# CONSTRUCTION TRAFFIC MANAGEMENT PLAN

Sydney Metro West – Western Tunnelling Package  
Clyde/ Rosehill Site Establishment

Document Title	Clyde/ Rosehill Site Establishment
Project Name	Sydney Metro West – Western Tunnelling Package
Client	Sydney Metro
Document Reference No.	SMWSTWTP-GLO-CLJ-TF-PLN-000001
Revision Date	6 May 2022

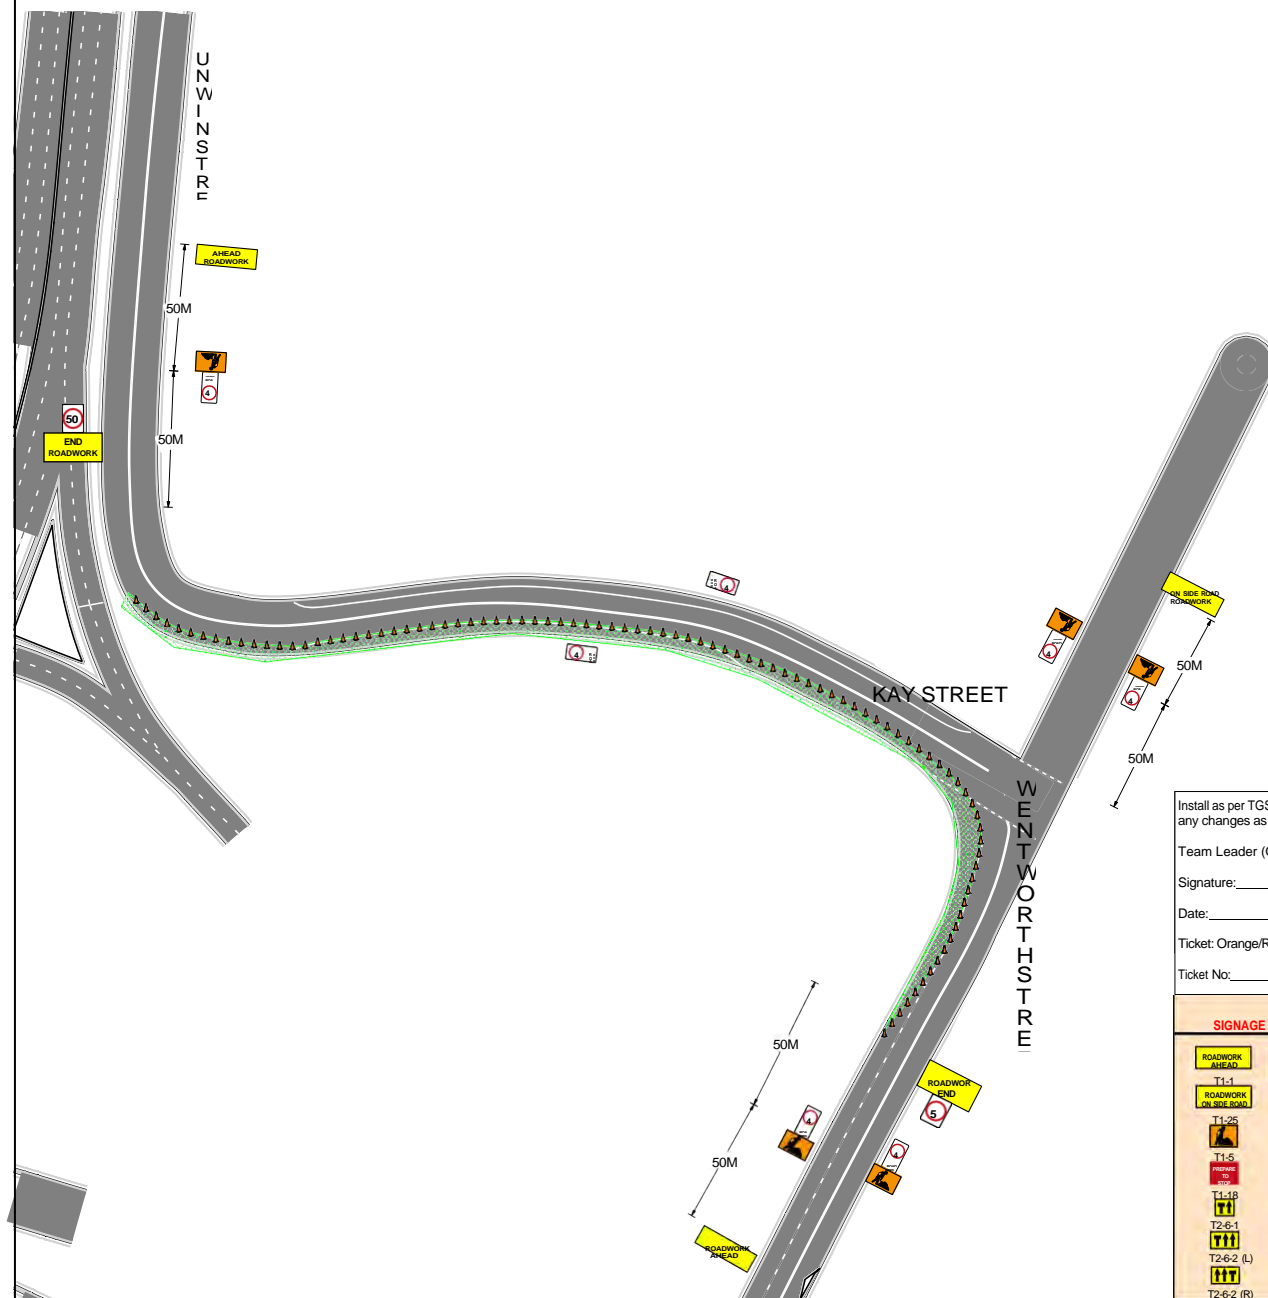
TGS-CLY-KAY-EB-2201				
28.	No road safety issues are identified. However, there is potential for parked vehicles along the kerb on northern leg of Wentworth Street to obscure proposed advance warnings signage.	Review whether the proposed signs can be obscured by parked vehicles. It may be necessary to post mount the signs or ban parking where advance signage is proposed.  Risk: Low	To be monitored during installation	Ongoing

D KELLY	SMWSTWTP-GLO-CLJ-TF-PLN-000001	Section 3.4	N/A	Document amended	Observation	N
				05	14/04/2022	SMD	SCLARKE	SMWSTWTP-GLO-CLJ-TF-PLN-000001	Appendix B TGSCLYKAYEB2201 Sheet 1 of 2	N/A	Wentworth street has two lanes on the southern approach. Should there be a vehicle in the left lane at the portable boom barrier which may reduce the visibility of the portable boom barrier for approaching vehicle the right lane. Consider lane taper on approach to single lane to reduce risk in line with TCAWS manual. Additionally why is the road works speed limit at 30 km/h when all other TGS are 40 km/h?	Observation	N
							D KELLY	SMWSTWTP-GLO-CLJ-TF-PLN-000001	Appendix B TGSCLYKAYEB2201 Sheet 1 of 2	N/A	TGS amended	Observation	N
				06	14/04/2022	SMD	SCLARKE	SMWSTWTP-GLO-CLJ-TF-PLN-000001	Appendix B TGSCLYSHINB1201	na	The TCG has lane closure (in yellow on plan) on the eastern approach along Unwins st on approach to Shirley St for a distance of 50m. This distance incorporates both the entry and exit to Viola. Consider how access is to be maintained in conjunction with the taper/lane closure cones	Observation	N

Location:	SHIRLEY STREET	
	TCP No:	TGS-CLY-SHI-SB-2201	
	Sheet No:	1 OF 1	
DRAWN BY:		SUE LEWIS	
CERTIFICATE NO:		0022818927	
SIGNATURE:			
PLAN CHECKED BY:		SUE LEWIS	
CERTIFICATE NO:		0022818927	
SIGNATURE:

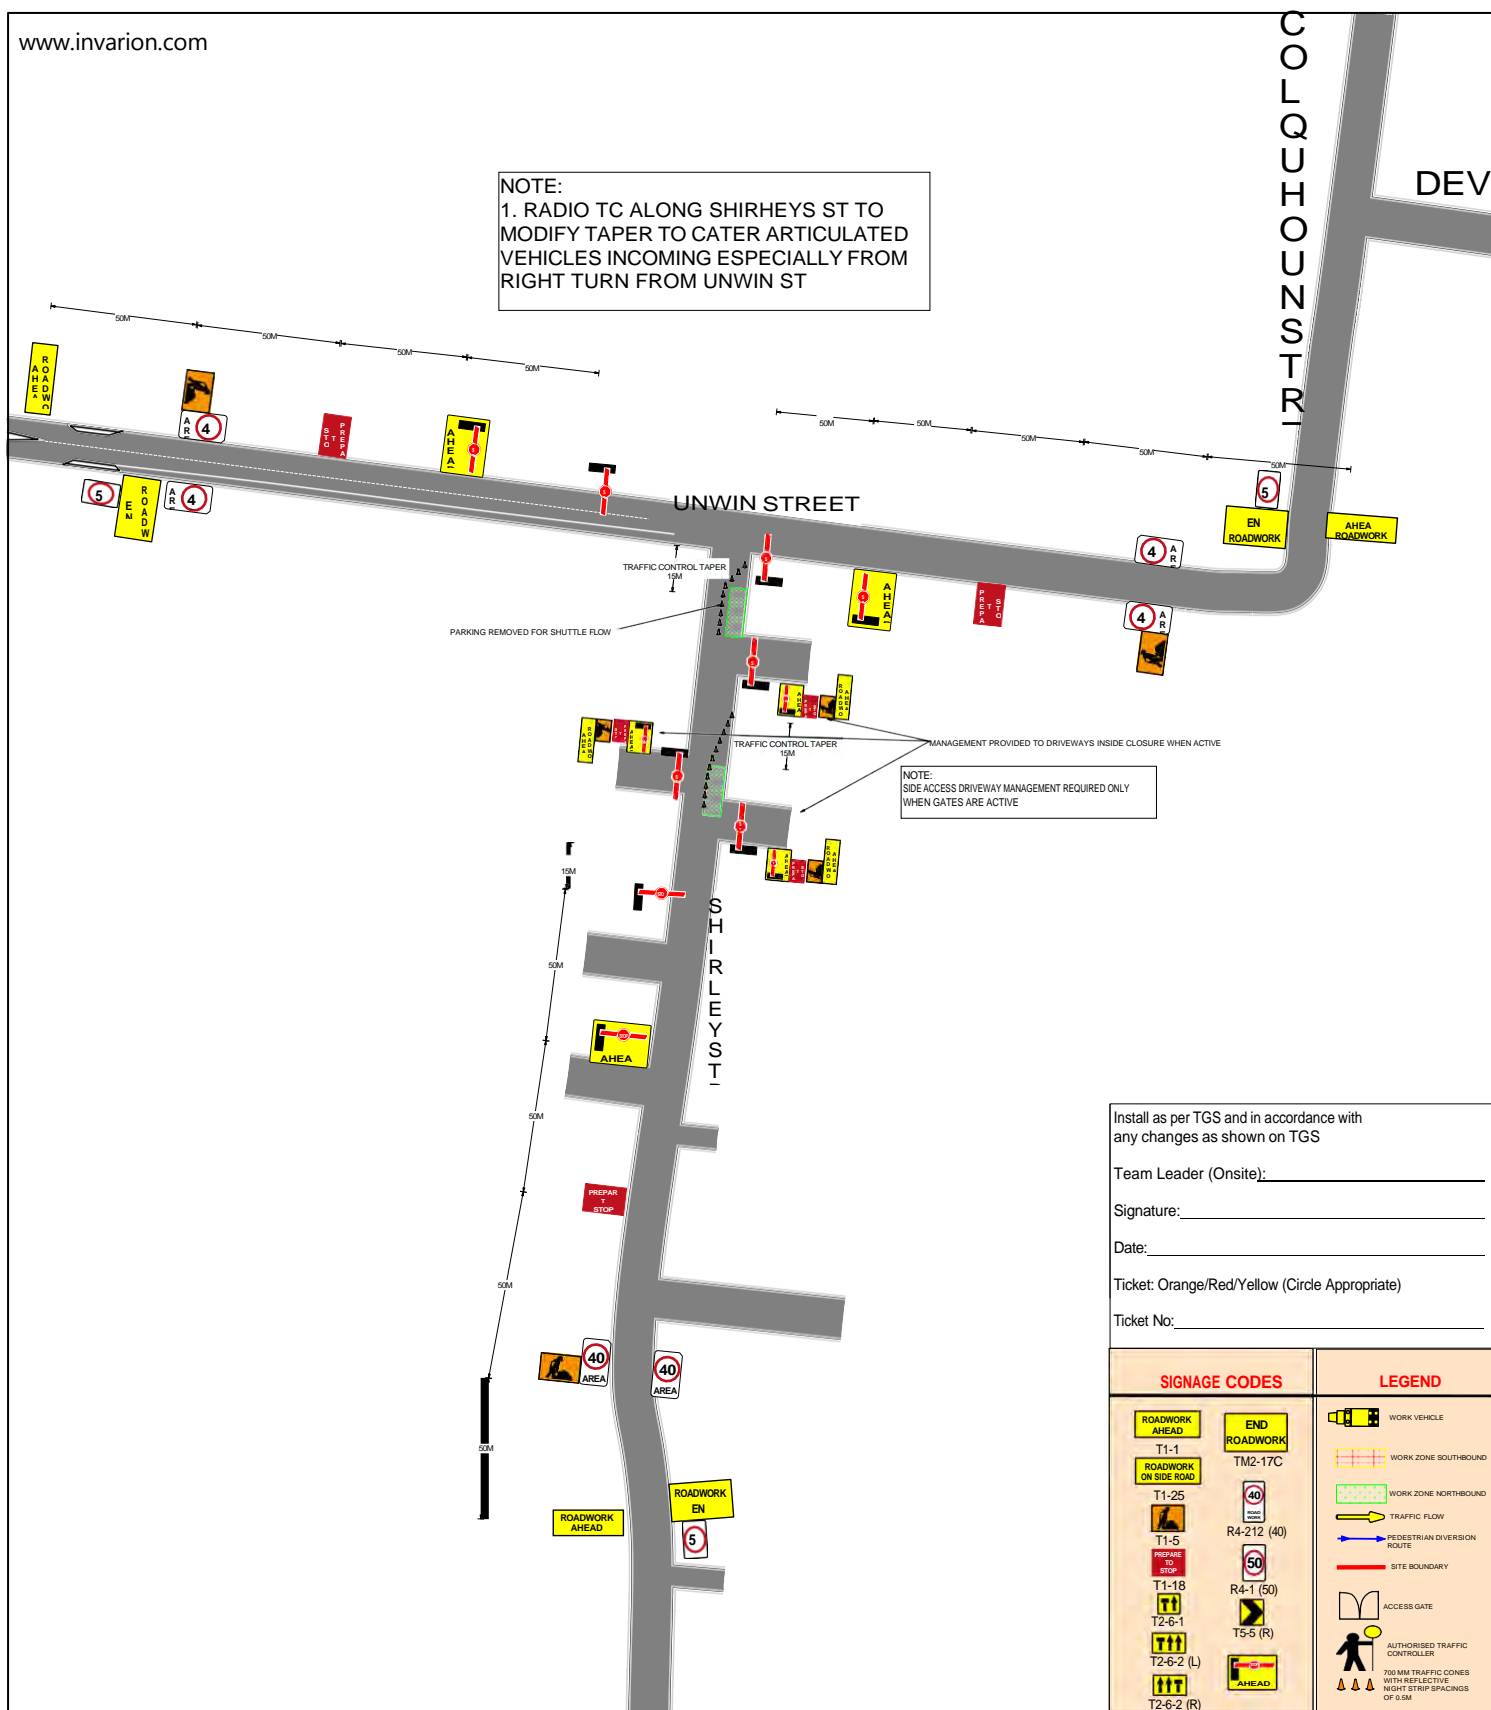
8.	Similar issue as audit point 5.	Refer to audit point 5.	Refer to response to point 5	Closed
9.	It may be difficult for an articulated vehicle to turn right from Unwin Street into Shirley Street due to the proximity of the work area to the intersection.	Review and confirm that the turning movement swept path of the expected articulated vehicle can be accommodated.  Risk: Low	Note added to TGS to facilitate those movements	Closed

NOTE:  
1. RADIO TC ALONG SHIRHEYS ST TO  
MODIFY TAPER TO CATER ARTICULATED  
VEHICLES INCOMING ESPECIALLY FROM  
RIGHT TURN FROM UNWIN ST
